MONTGOMERY COUNTY HISTORIC PRESERVATION COMMISSION
STAFF REPORT

| Address: | 7402 Carroll Ave., Takoma Park | Meeting Date: | 09/06/17 |
| Case Number: | 31/06-17JJJ | Staff: | Dan Bruechert |
| Proposal: | Building Rehabilitation | | |

Front Door
Like to Replace
7402 front &
Screen Door to
MATCH

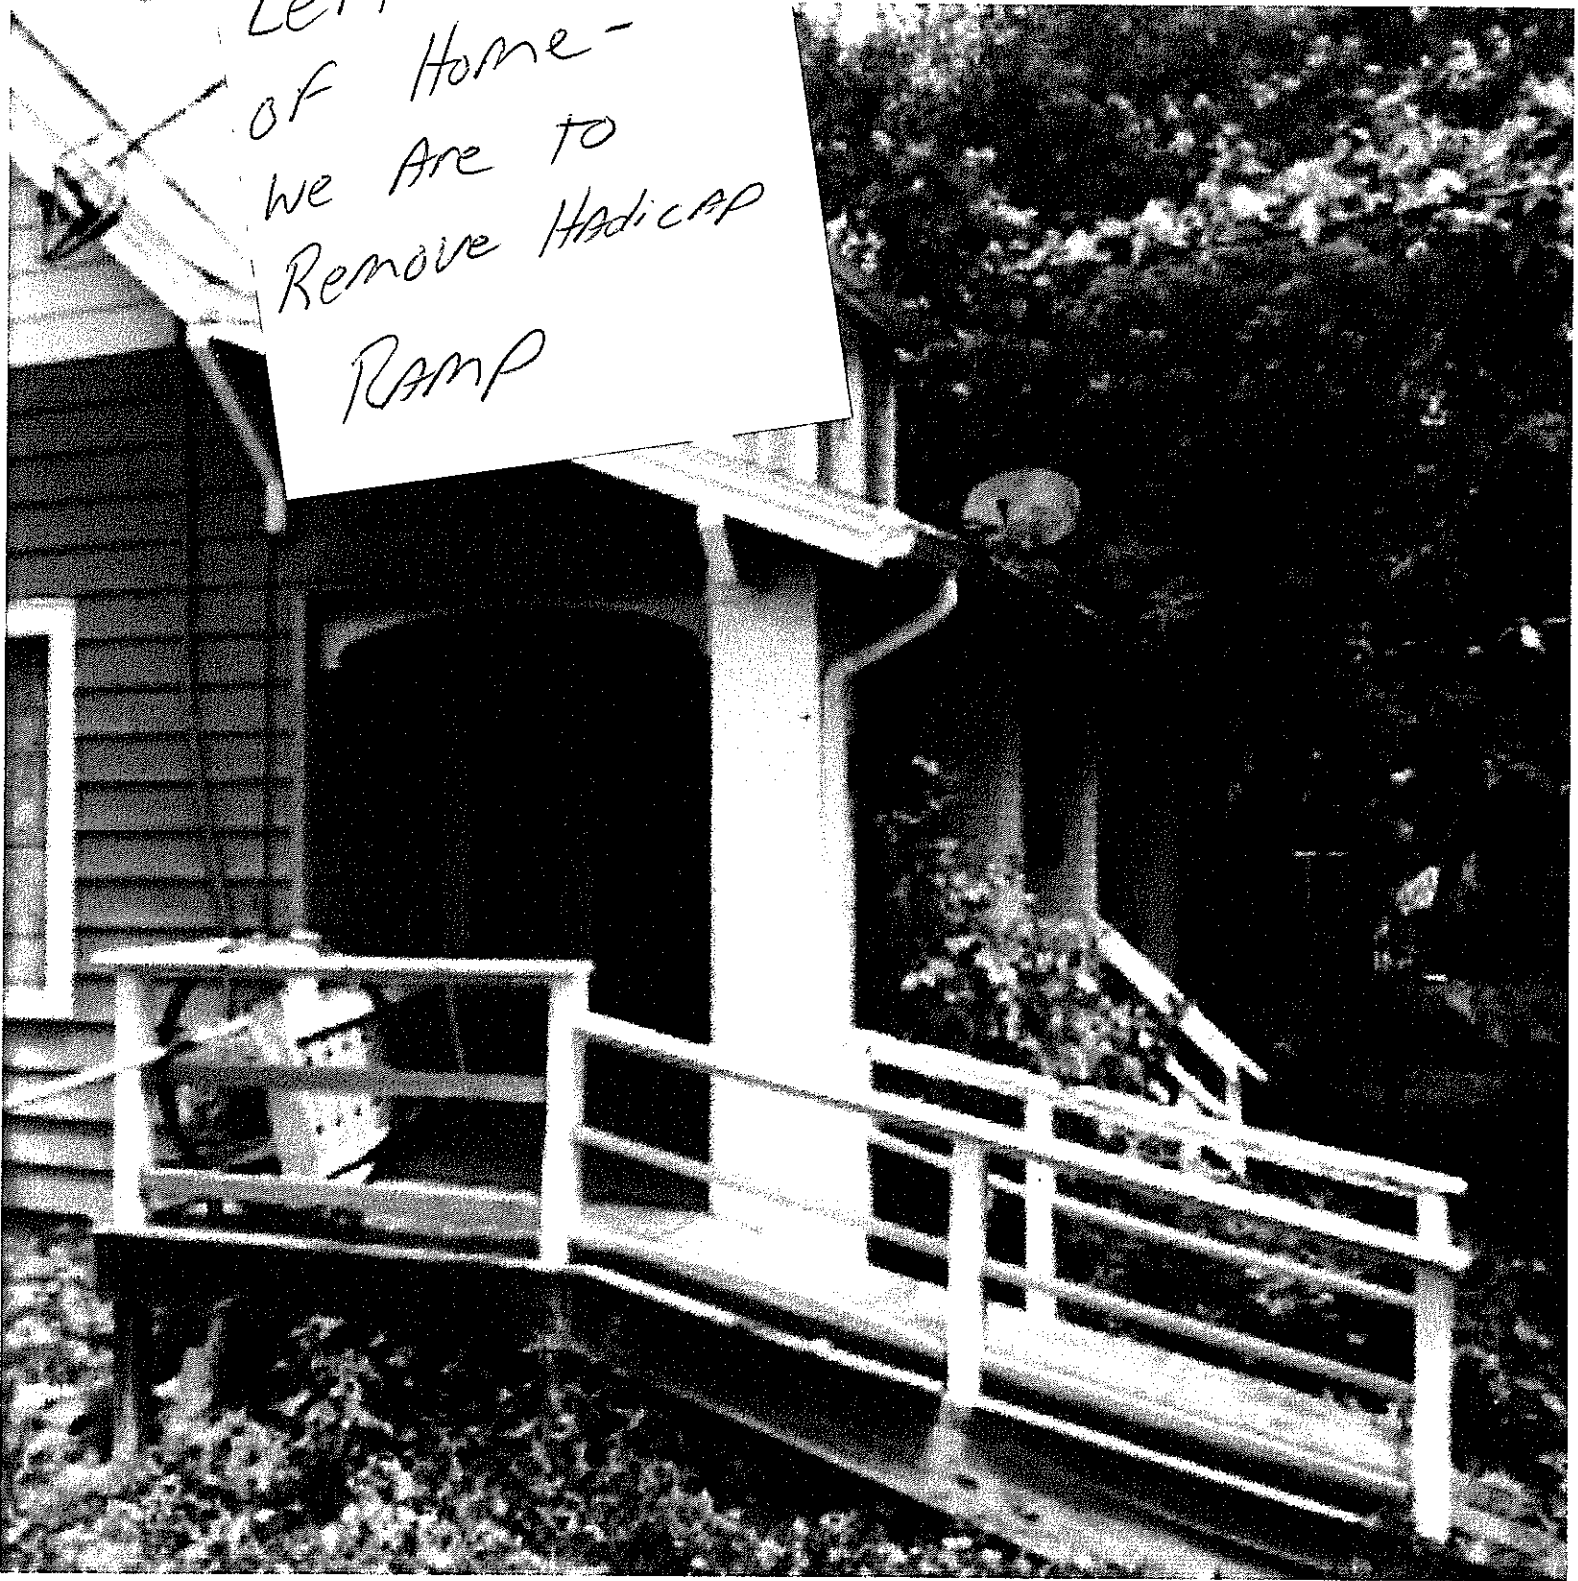
- The new front door must be given a painted finish.

The non-historic front door was lost in the fire and has to be replaced. The applicant is proposing to replace the front door with a Craftsman design, solid wood door with six fixed lites. The door is an appropriate design for both the house and the surrounding district, complying with the *Design Guidelines* which state, "All exterior alterations, including those to architectural features and details, should be generally consistent with the predominant architectural style and period of the resource." The door is to be delivered to the applicant in an unfinished state and Staff believes that a painted finish would be appropriate for the historic character of the building and that staining the exterior of the door is not in keeping with the character. Staff recommends conditioning the approval of this Historic Area Work Permit on the new front door receiving a painted finish.

- The new front door shall be given a painted finish.

Reinstalling
Original Rail
After We Remove
Ramp

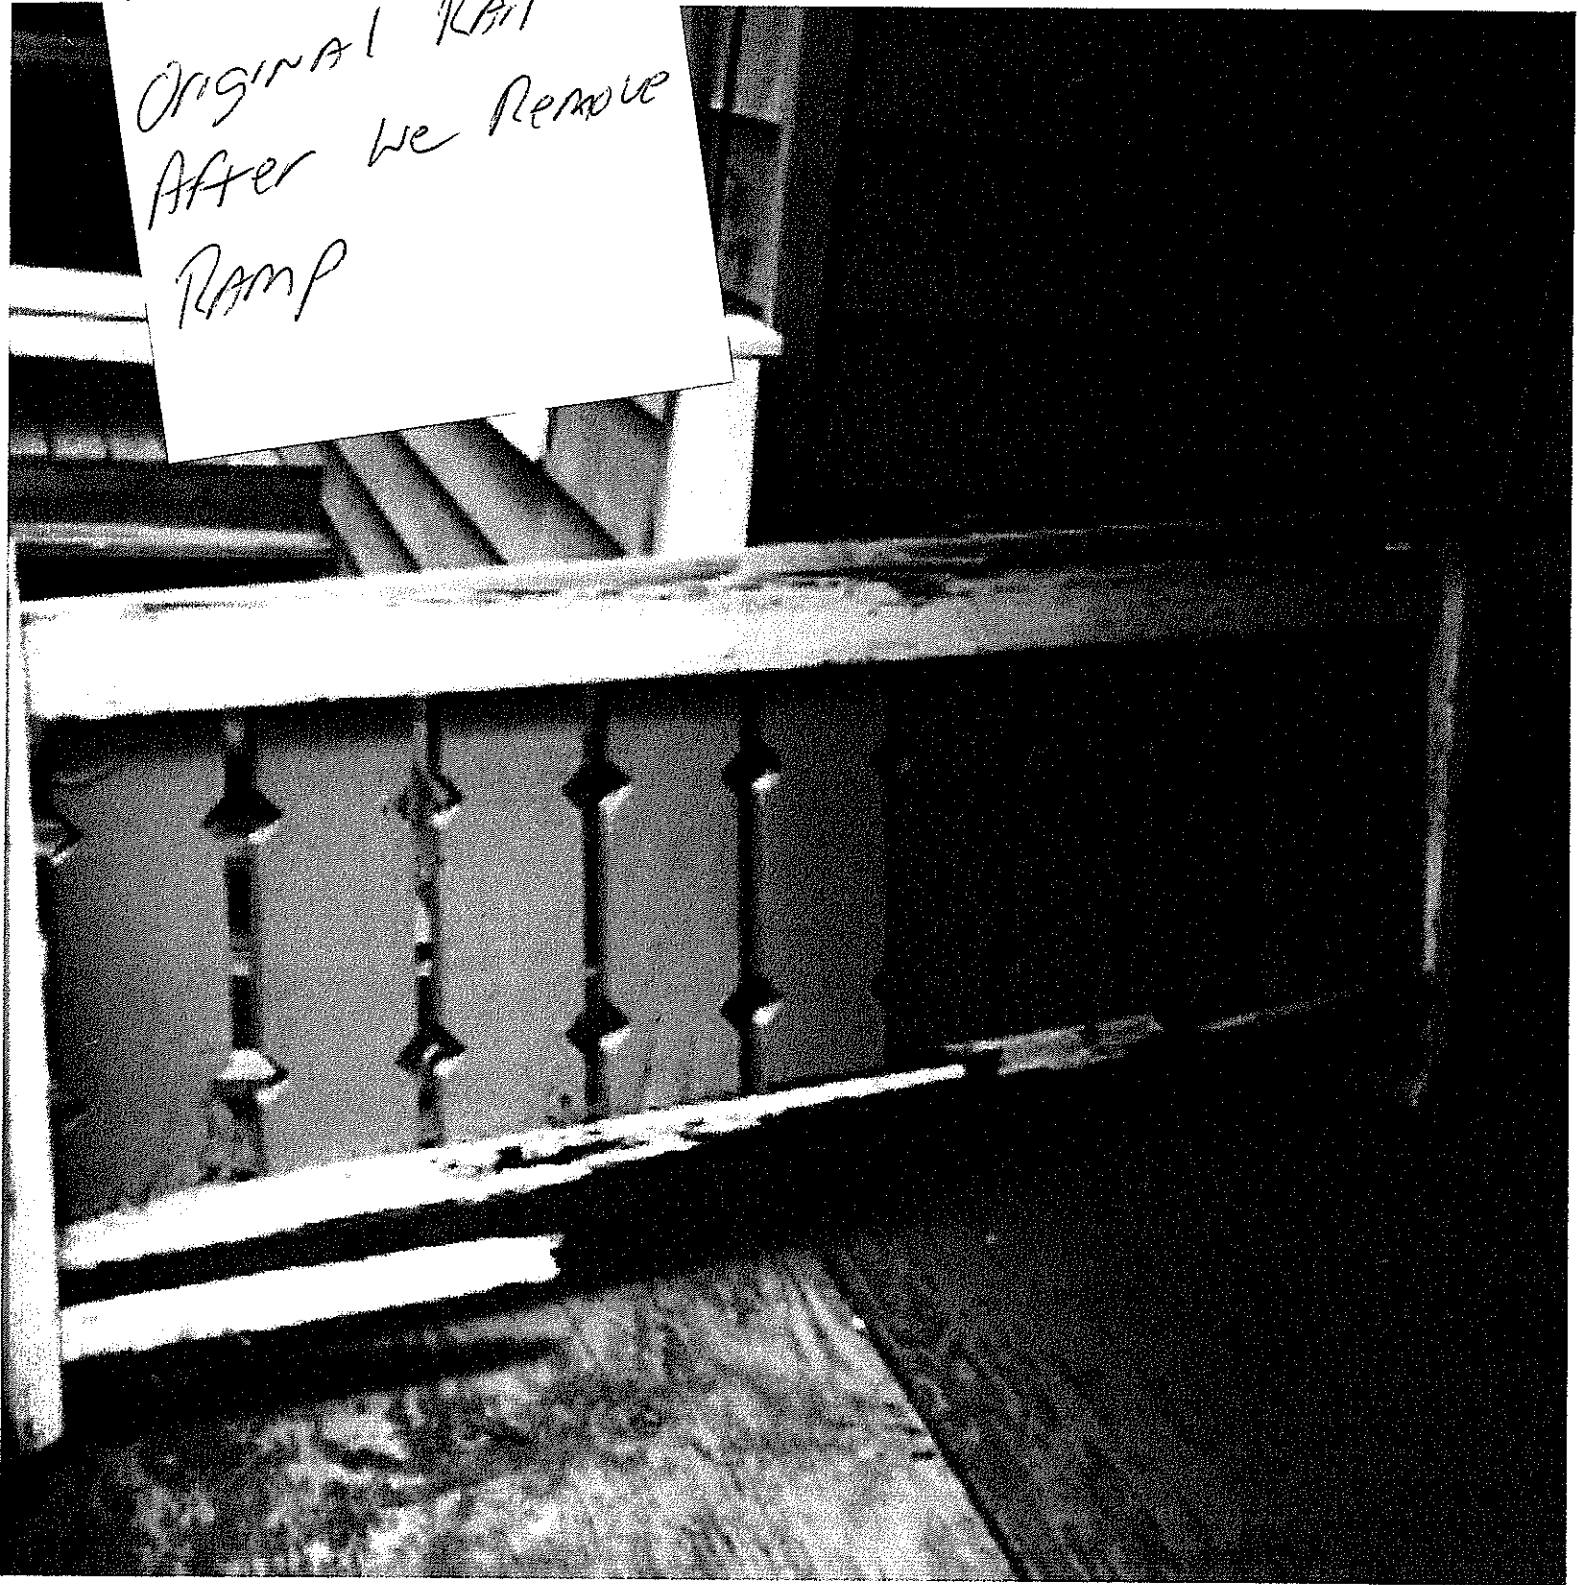
To the left of the front porch is an accessibility ramp. The ramp is significantly degraded and does not contribute to the historic character of the house. Staff was unable to locate a building permit or a HAWP for this element and it is possible it was constructed before the designation of the district. The applicant is proposing to remove the ramp and to reinstall the historic railing. The historic railing was discovered in the house crawlspace and the applicant will make necessary repairs to the railing using in-kind material. This portion of the proposal is a restoration and should be approved.
